Planning & Development Division
Planning & Economic Development Department

File Number	PL 23-038	Contact	Kyle Deming	
Type	Special Use Permit – Restaurant	Planning Commission Date		March 14, 2023
Deadline for Action	Application Date	February 17, 2023	60 Days	April 18, 2023
	Date Extension Letter Mailed	February 23, 2023	120 Days	June 17, 2023
Location of Subject	Southwest corner of Anderson Rd. and Central Entrance (Mall Area)			
Applicant	The Jigsaw, LLC	Contact	Dan Regan	
Agent	Kimley-Horn	Contact	Brian Wurdeman	
Legal Description	Lot 2, Block 1, Jigsaw Division			
Site Visit Date	March 3, 2023	Sign Notice Date	February 27, 2023	
Neighbor Letter Date	February 24, 2023	Number of Letters Sent	24

A Special Use Permit to allow two restaurants in the Jigsaw development at the southwest corner of Central Entrance and Anderson Rd. The project will consist of a 2,500 sq. ft. restaurant and a 660 sq. ft. drive-thru coffee kiosk and related parking and landscaping.

Recommended Action: Approve with conditions.

SHEET NUMBER
C3.0

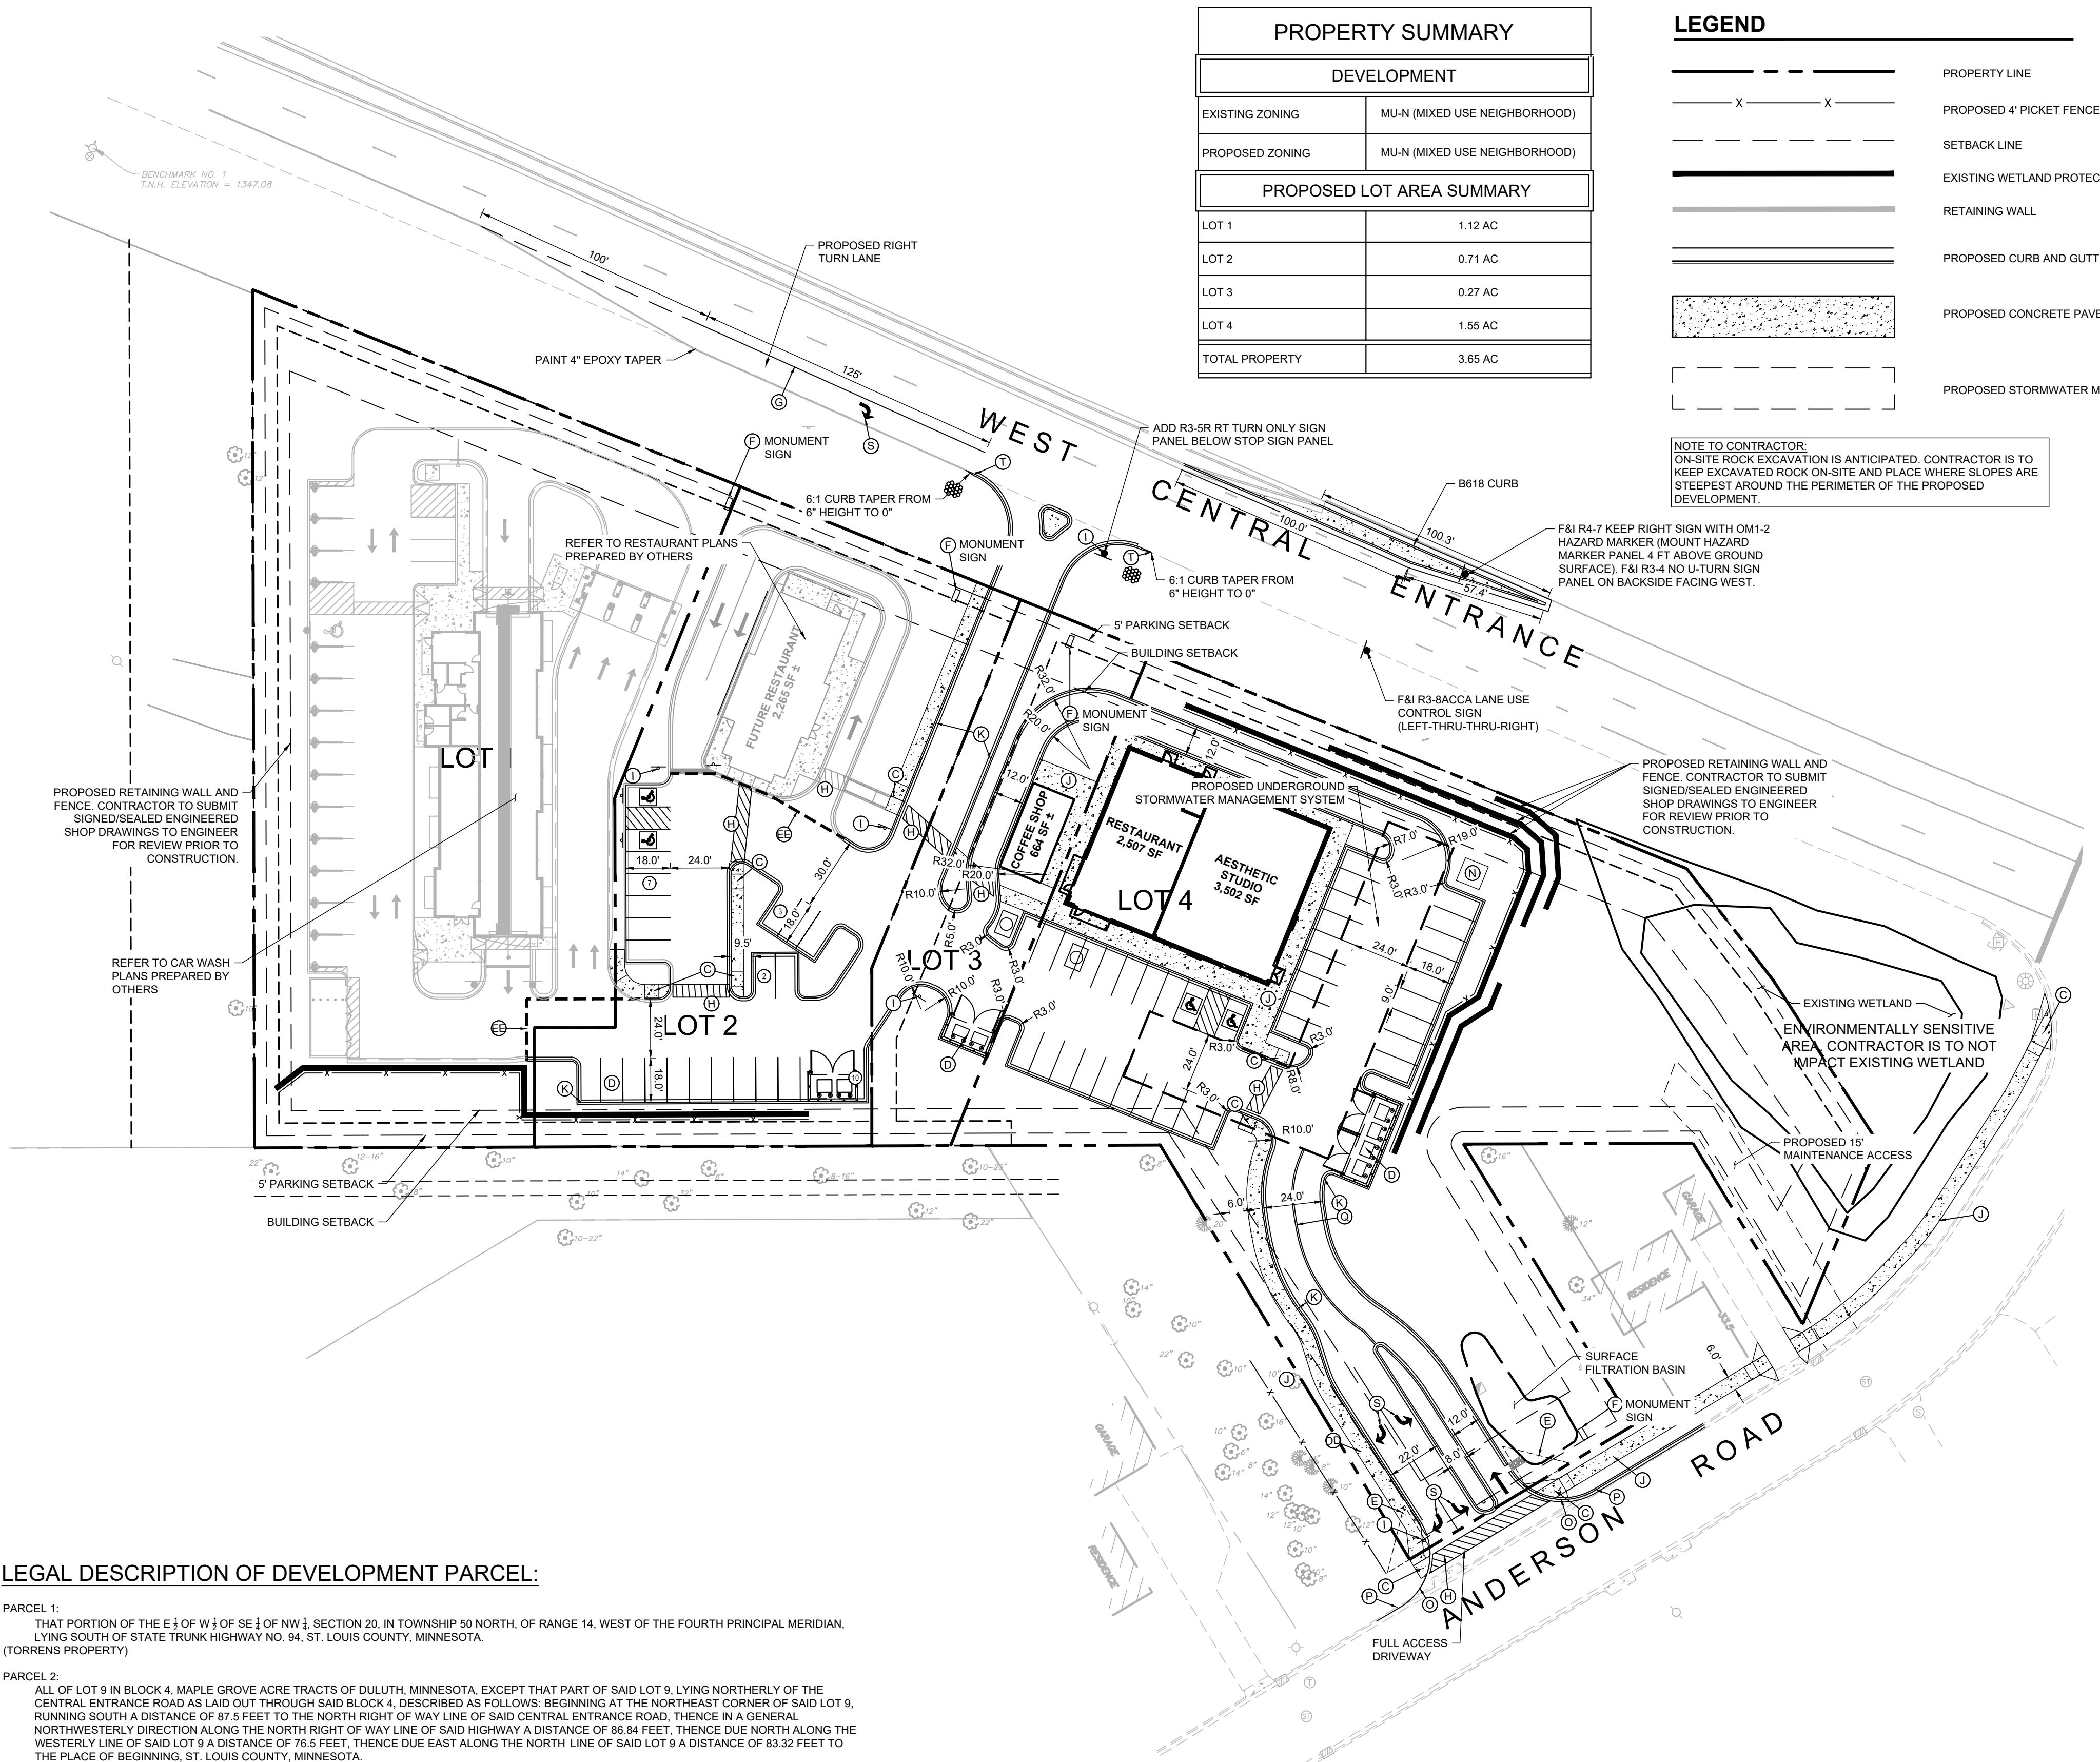
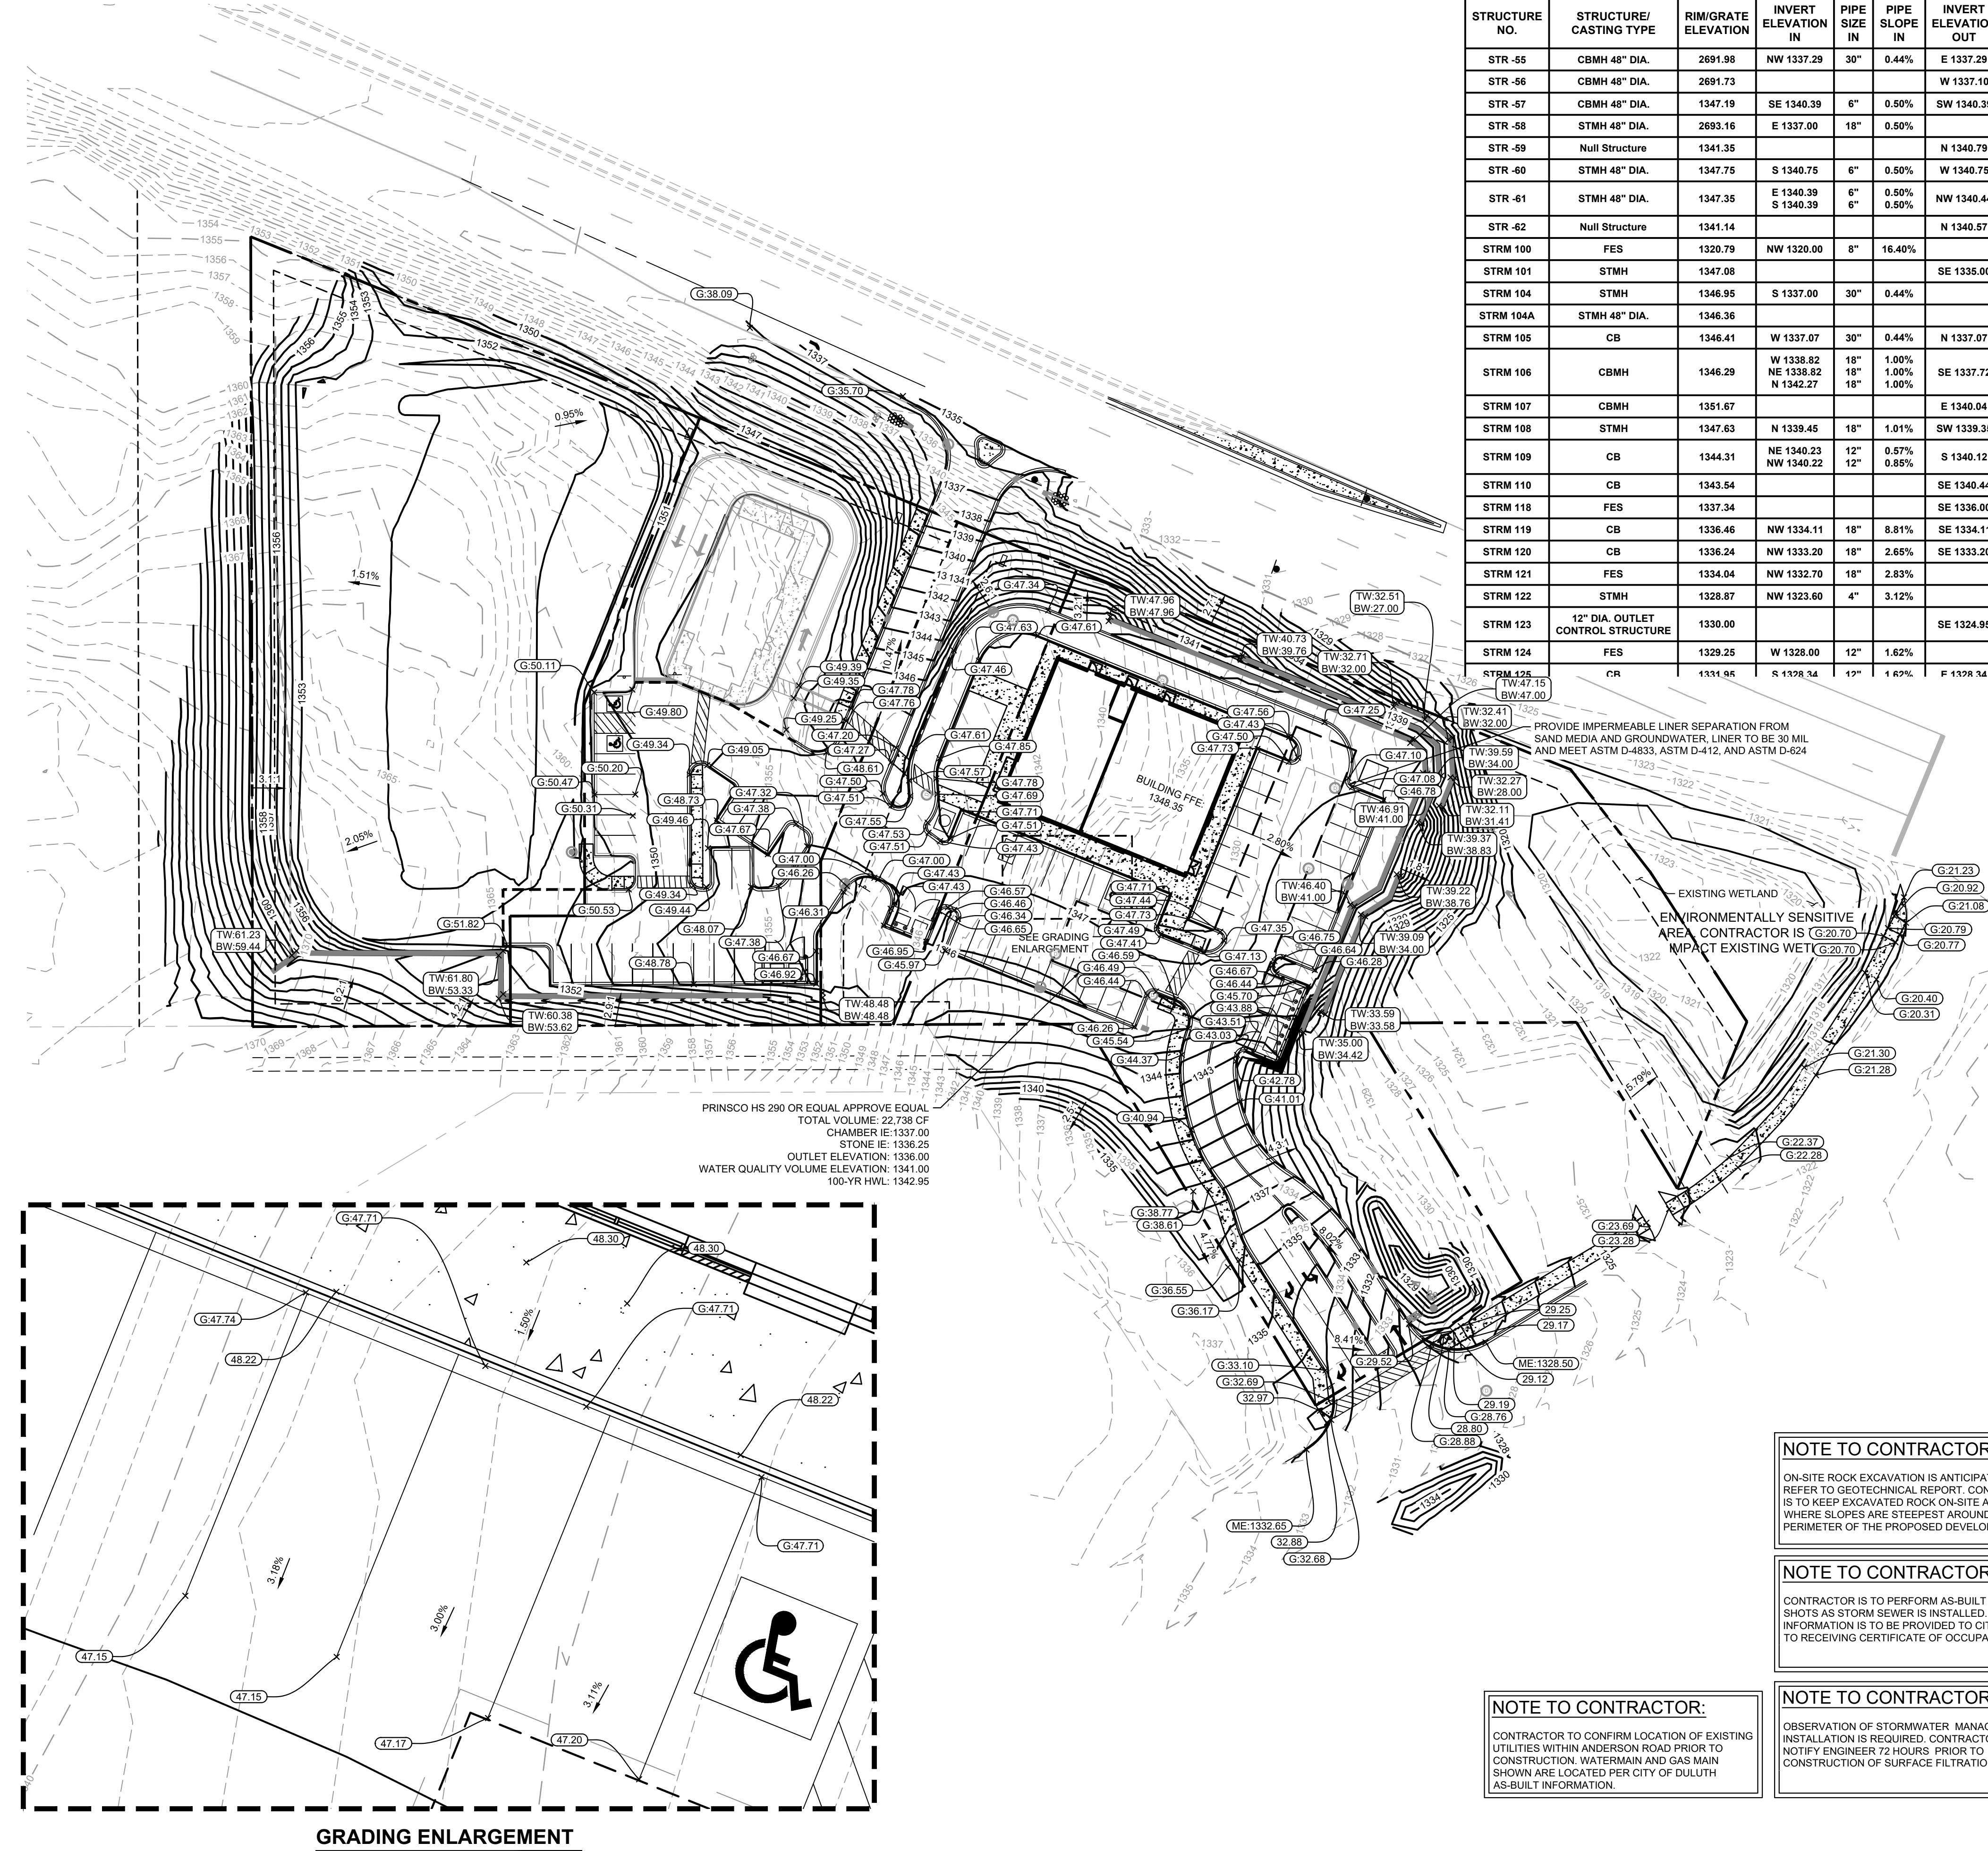
4. The site plan shows 38 parking spaces for the two proposed restaurants and anticipated personal service use. This is within the range allowed for the three businesses (minimum of 29 parking spaces and a maximum of 43 spaces).

7. HVAC mechanical units are not shown and will need to be screened from view, which can be verified at time of building permit application.
8. Trash screening is shown on the plans with compliant materials.

9. Retaining wall shown on the site plan complies with height limits, including required landscaping between terraces.
10. Ground-mounted and building mounted signs shown on the plans will need to comply with the Master Sign Plan, which is to be reviewed by the Planning Commission at this March meeting (PL 23-021).
